STAFF RECOMMENDATION
913 Lawrence Avenue
August 19, 2020

Application: New Construction—Infill and Outbuilding/ Detached Accessory Dwelling Unit

District: Waverly-Belmont Neighborhood Conservation Zoning Overlay

Figure 1. 913 Lawrence Avenue.

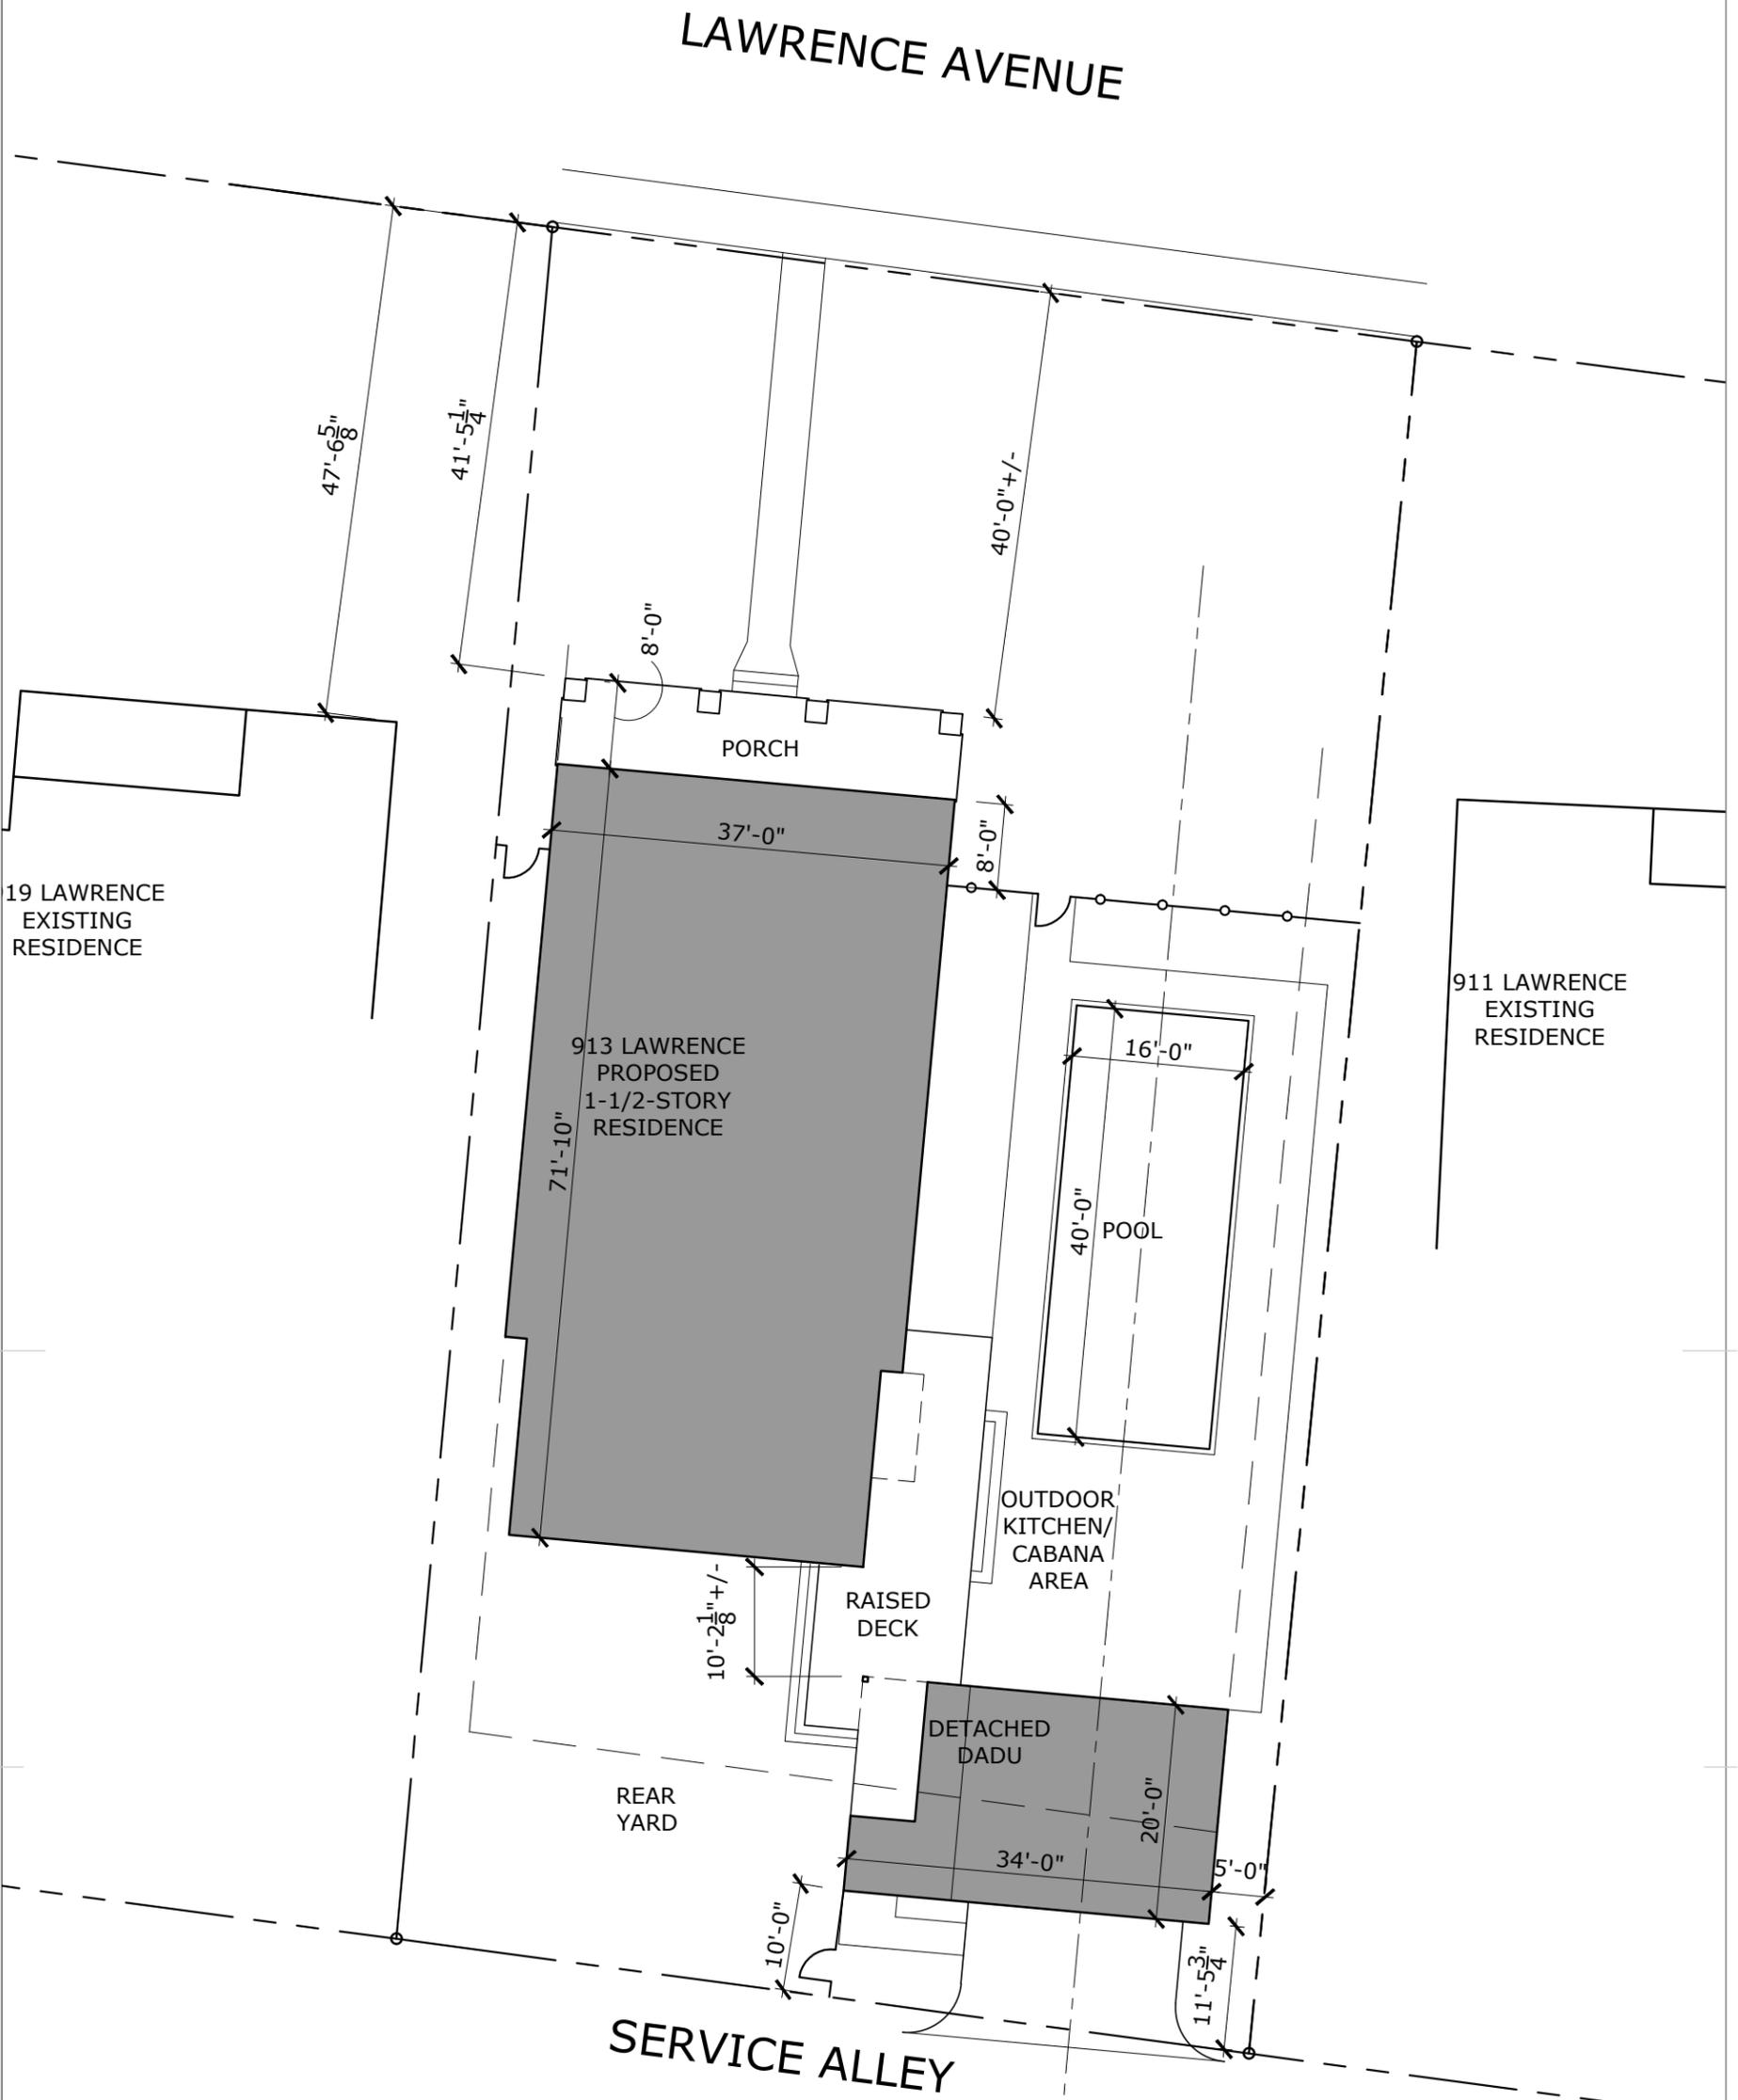
Background: 913 Lawrence Avenue is a c. 1950 cinder block house that does not contribute to the historic character of the Waverly-Belmont Neighborhood Conservation Zoning Overlay (Figure 1). MHZC staff issued an administrative permit for the demolition of the house in July 2017, but the house was not demolished. The 2017 permit expired but MHZC staff issued a new demolition permit in August 2020. In 2017, the applicant also applied for an infill that is similar in design to what is proposed in this application. The Commission approved the plans, with conditions, but the applicant never submitted the final materials for a permit.

SITE PLAN

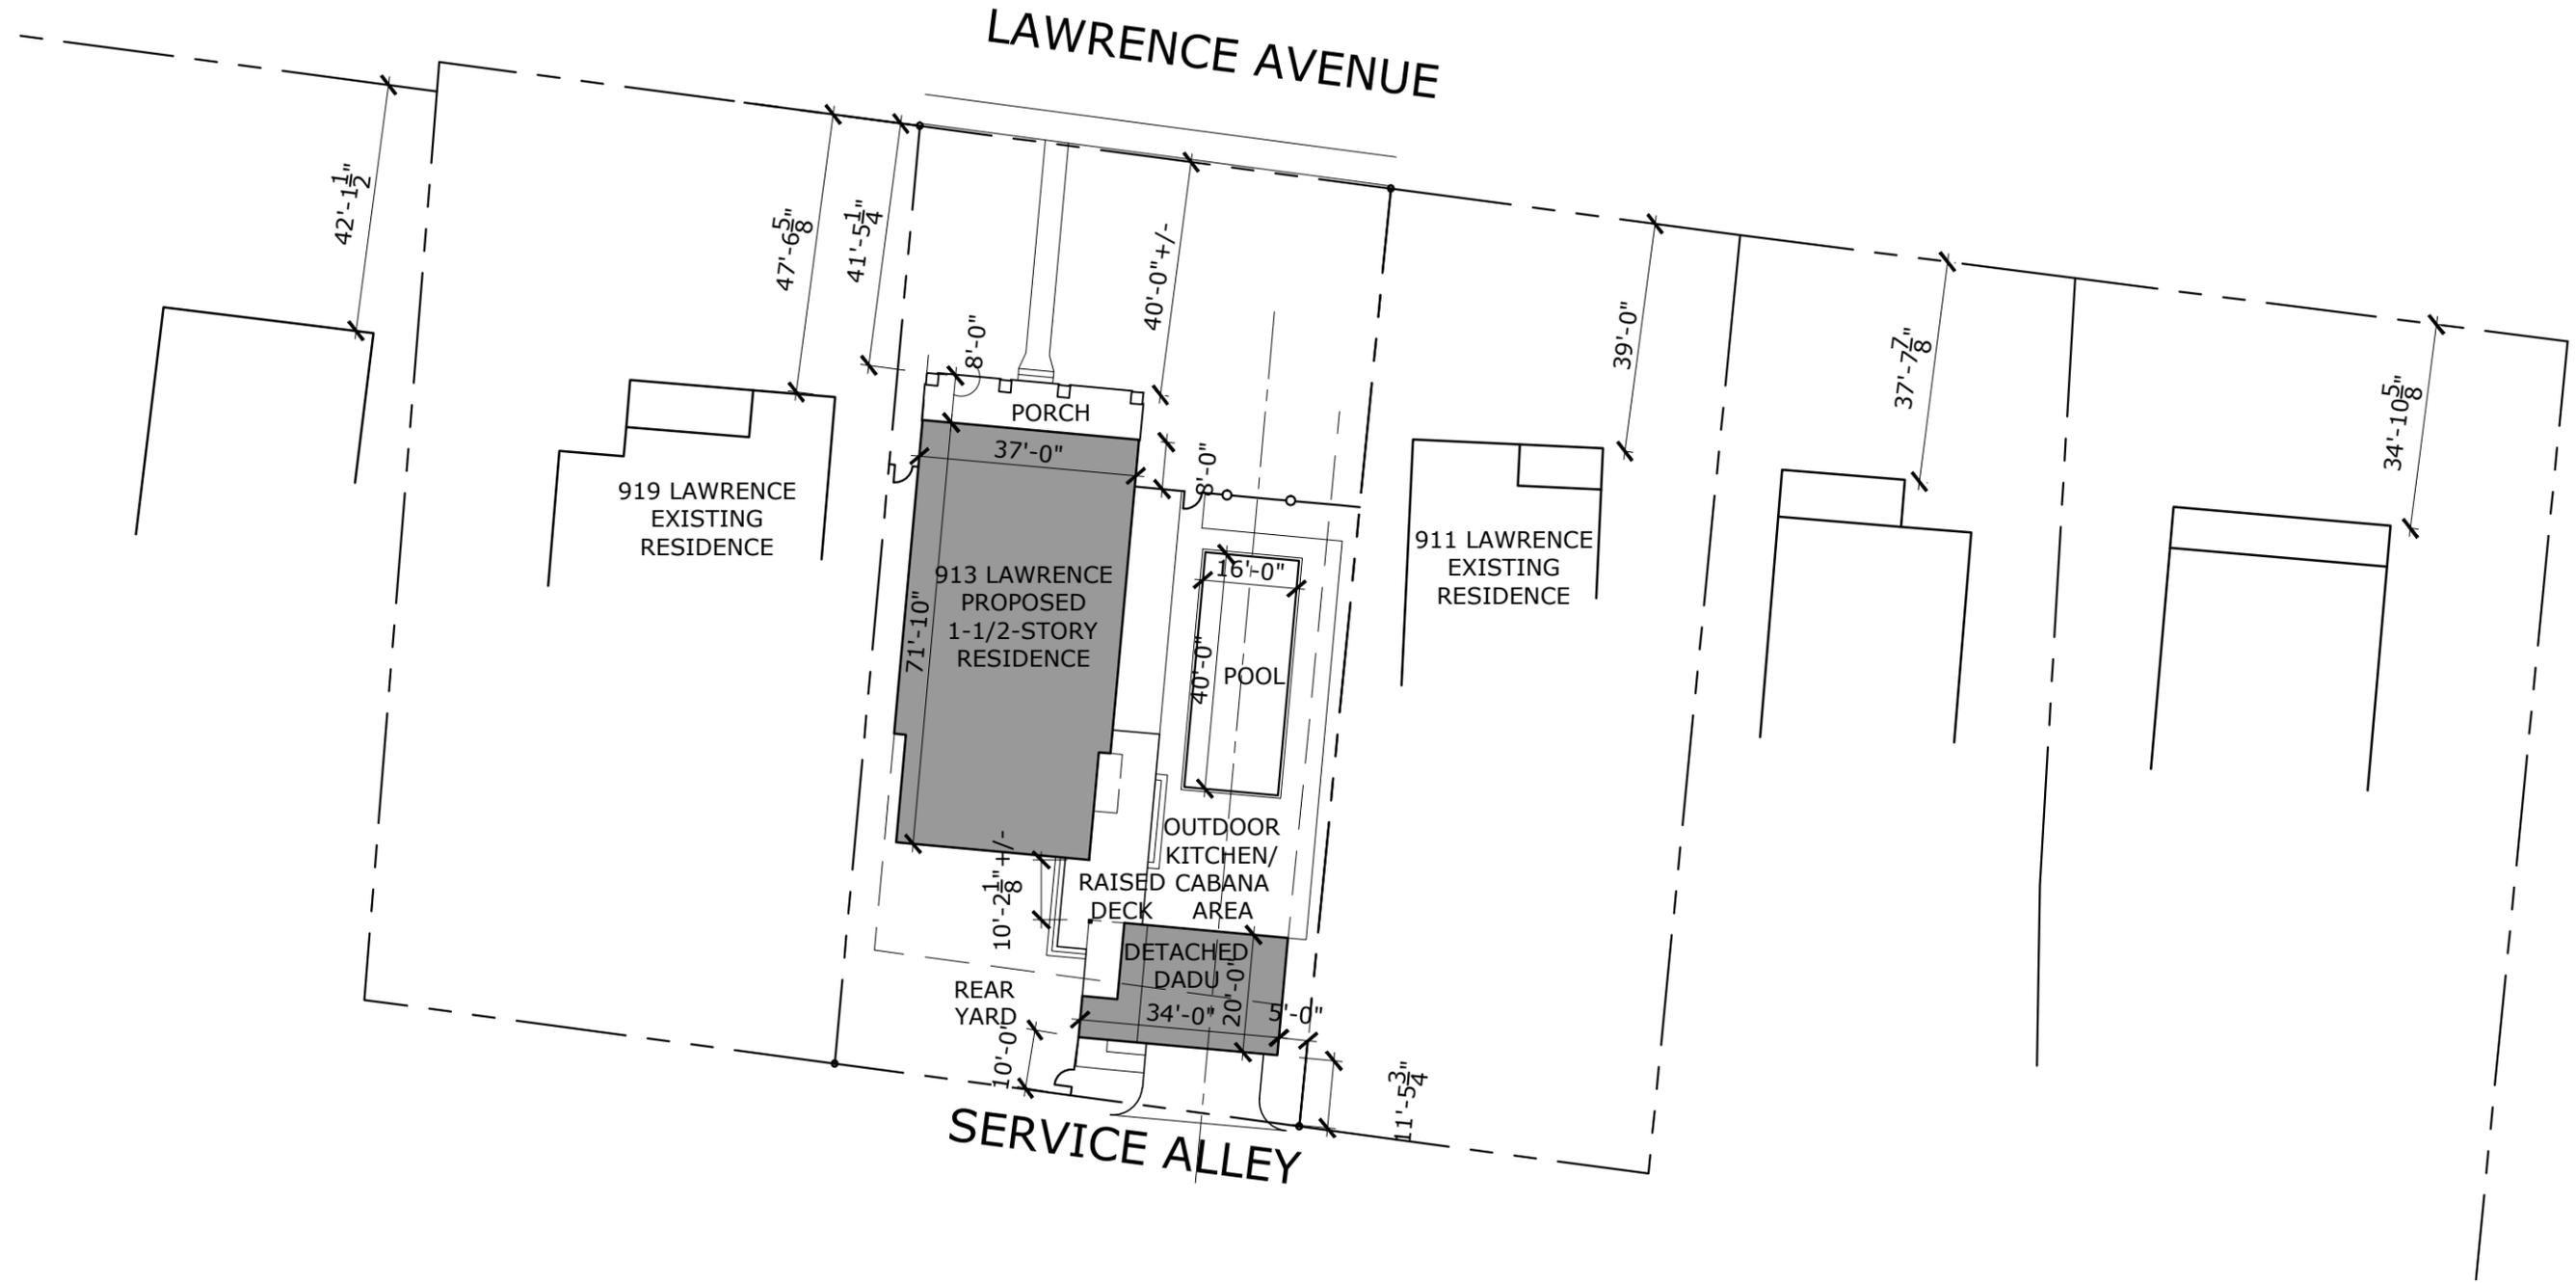
Setback & Rhythm of Spacing: The proposed infill meets all base zoning setback. It will be approximately five feet, six inches (5’-6”) from the right-side property line, thirty-eight feet (38’) from the left side property line, and thirty-eight feet (38’) from the rear property line. The house is not centered on the wide lot. Staff finds this to be appropriate because the previous house on the lot was not centered on the lot, and other houses on wide lots in the immediate vicinity are not centered on the lot. Staff therefore finds that the house’s placement on the lot will not affect the rhythm of spacing along the street.

The house’s porch will be forty feet (40’) from the front property line and the house’s wall will be forty-eight (48’) from the front property line. The front wall of the house will be setback slightly more than the front walls of the house next door and 919 Lawrence while the porch will be slightly forward of those houses. Staff finds this to be appropriate since both 911 and 919 Lawrence Avenue do not incorporate porches that project from the front wall while this one does. For this reason, staff finds that the proposed front setback can be appropriate in this case.

Minimum	Proposed
DADU rear setback	5'	10'
DADU left side setback	3'	5'
DADU right side setback	3'	40'
Distance between DADU and House	20'	10'*

*The design guidelines state that there should be a minimum of twenty feet (20') in between a primary structure and an outbuilding. As proposed, the DADU is located in the rear left corner of the property. Therefore, only a small part of the DADU will be ten feet (10') from the rear of the house since both are located off-center.

FRONT ELEVATION

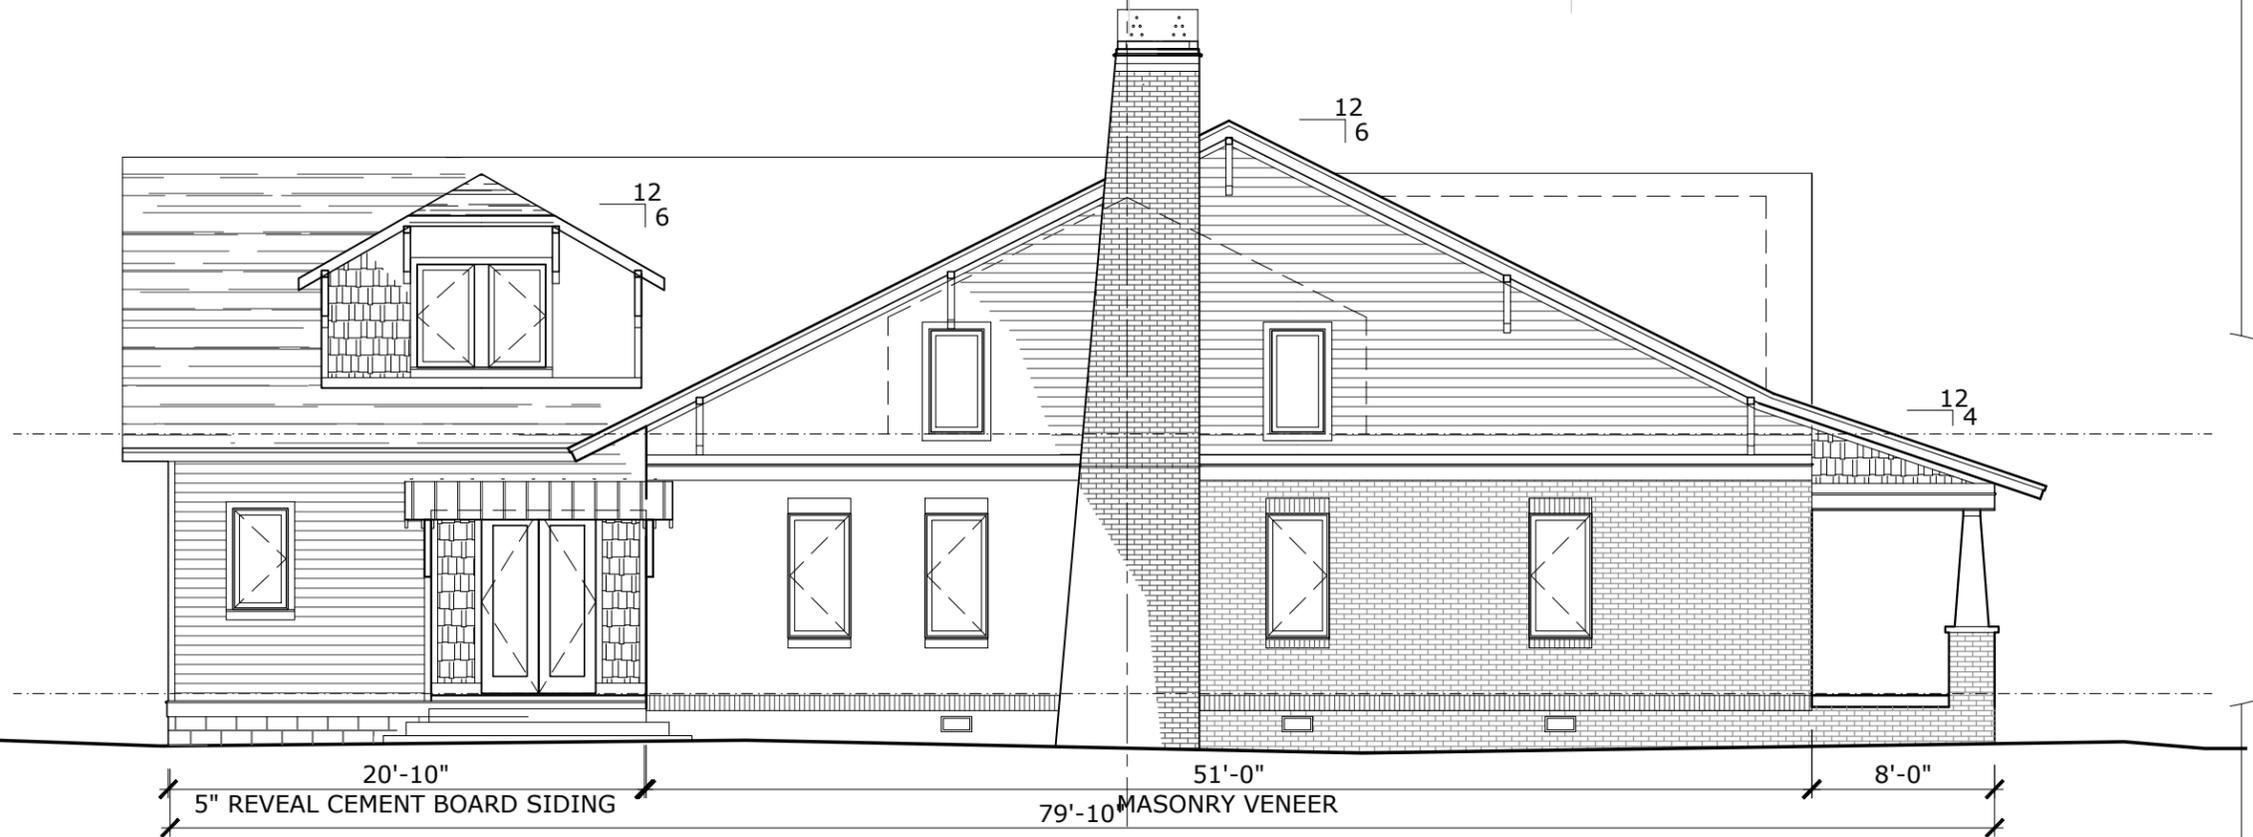
*The drawings do not show a change in material from the foundation line to the wall above. The design guidelines state, “Foundation lines should be visually distinct from the predominant exterior wall material. This is typically accomplished with a change in material.” Staff recommends that foundation material be different than the brick wall of the infill. Appropriate foundation materials could be stone, stucco, or split face concrete block.

Roof form: The primary roof form is a side gable with a cross gable element on the front façade. The side gable will have a slope of 6/12, and the front cross gable will have a slope of 8/12. The front porch will have a shed roof with a slope of 4/12. The rear

section of the house will have side dormers that have clipped gable roofs and are setback from the wall below by at least two feet (2'). Staff finds that the proposed roof form meets Section III.E. of the design guidelines.

1. The finished floor height be consistent with the finished floor heights of the adjacent historic houses, to be verified by MHZC staff in the field;
2. There be a change in material at the foundation line to delineate the foundation from the wall above;
3. The lap siding be smooth with a maximum reveal of five inches (5”);
4. Staff approve a brick sample;
5. Staff approve all windows and doors;
6. Staff approve the metal and shingle roof color and texture;
7. Staff approve the material of the side porch floor and steps; and
8. Staff receive a filed copy of the restrictive covenant for the DADU.
